# UNITED STATES PATENT AND TRADEMARK OFFICE

10/688,772

## **DETAILED ACTION**

Bremer (U.S. Pat. No. 2,482,835)

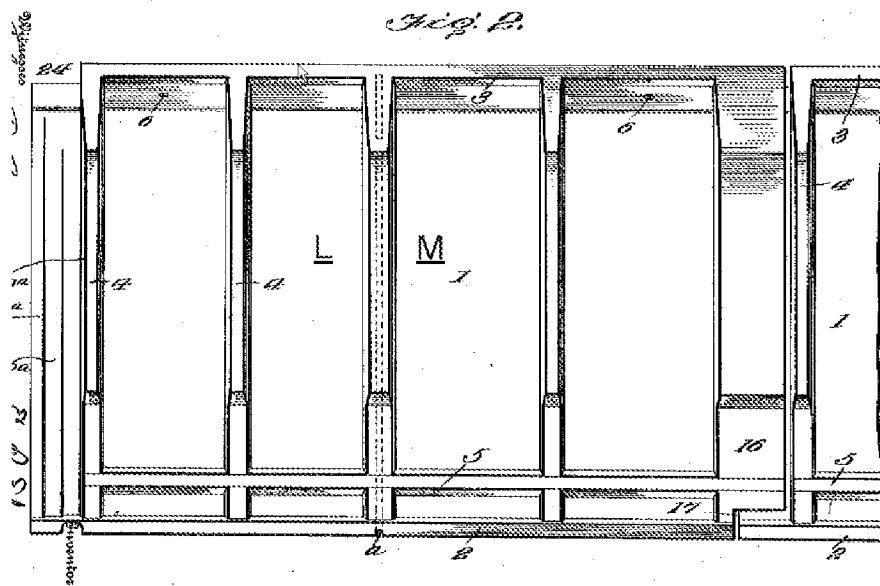
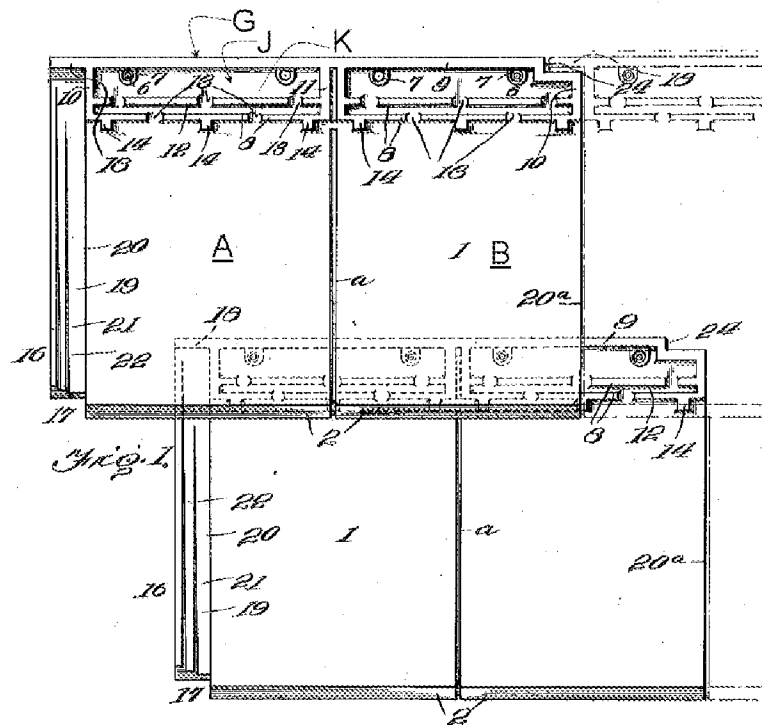
Furthermore, Bremer discloses a roof tile wherein there is an open side (a) opposite a side dam (b) for draining into the side waterlock (9). Therefore, it would have been obvious for a person having ordinary skill in the arts at the time of the Applicant's invention to modify the roof tile of Elzey to have an open side opposite the side dam for draining into the side waterlock as taught by Bremer so that water may drain out of the head lap and into a channel.

Elzey (U.S. Patent No. 1,124,001)

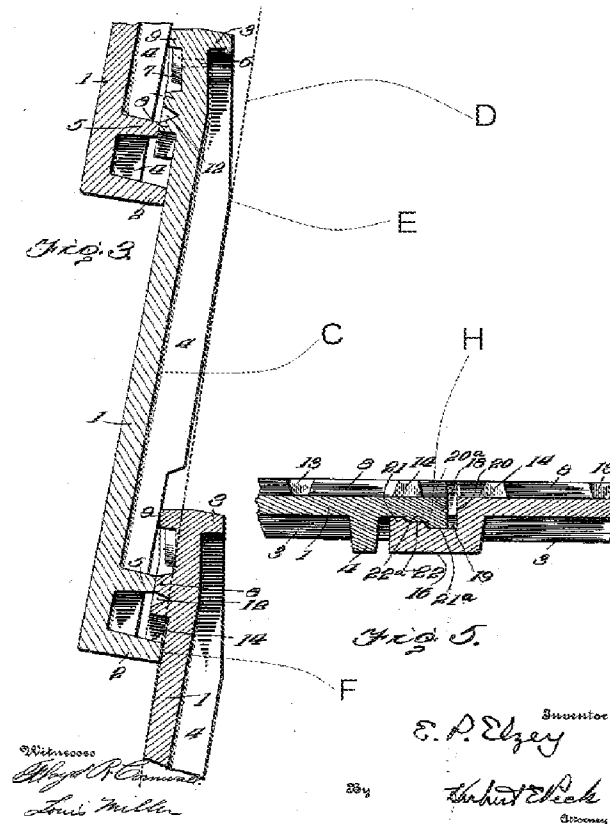
Regarding claim 18, Elzey discloses a molded composite roofing tile with a front and a back, a top and bottom, and opposite outer sides; the tile comprising, an image section (1) with a plurality of tile or shingle images (A, B) having backsides (c) raised from a datum plane (D), a substantially constant front-to-back thickness (as shown in Figure 3), bottom edges (2) that establish the bottom of the image section, and outer sides (20, 20a) that establish opposite outer sides of the image section, and a visually

distinct divider (a) extending adjacent each of the images; the back of said image section having support surfaces (E, F) at said datum plane, and reinforcing ribs (4) extending rearwardly to no further than said datum plane; a head lap (G) with an upper waterlock (8) along the top of the image section, the upper waterlock having a shelf (J) extending along the length thereof, an uninterrupted upper dam (9) to resist flow of water over the top of the shelf, an uninterrupted side dam (10) to resist flow of water out one side of the shelf, and an interrupted lower dam (8) for controlled flow of water out the bottom of the shelf toward the image section therebelow, laterally spaced fastener-receiving formations (6) proximate the lower dam, the fastener-receiving formations having pre-formed tapered fastener openings (as shown in outline form in Figure 3) and being raised from the shelf (via 7) to resist water flow into said openings; a side water lock (16) along one of said outer sides of the image section, the side waterlock having a forwardly facing channel (21a) substantially along the length thereof and proximate but above the bottom of the image section; and a side overlap (H) facing rearwardly along the other of said outer sides of the image section, the side overlap being configured for side-to-side adjustable positioning into the side waterlock channel of an adjacent tile when installed onto a roof, the channel and side overlap further having complimentary profiles to establish side-to-side self-centering between adjacent installed tiles (as shown in Figure 5).
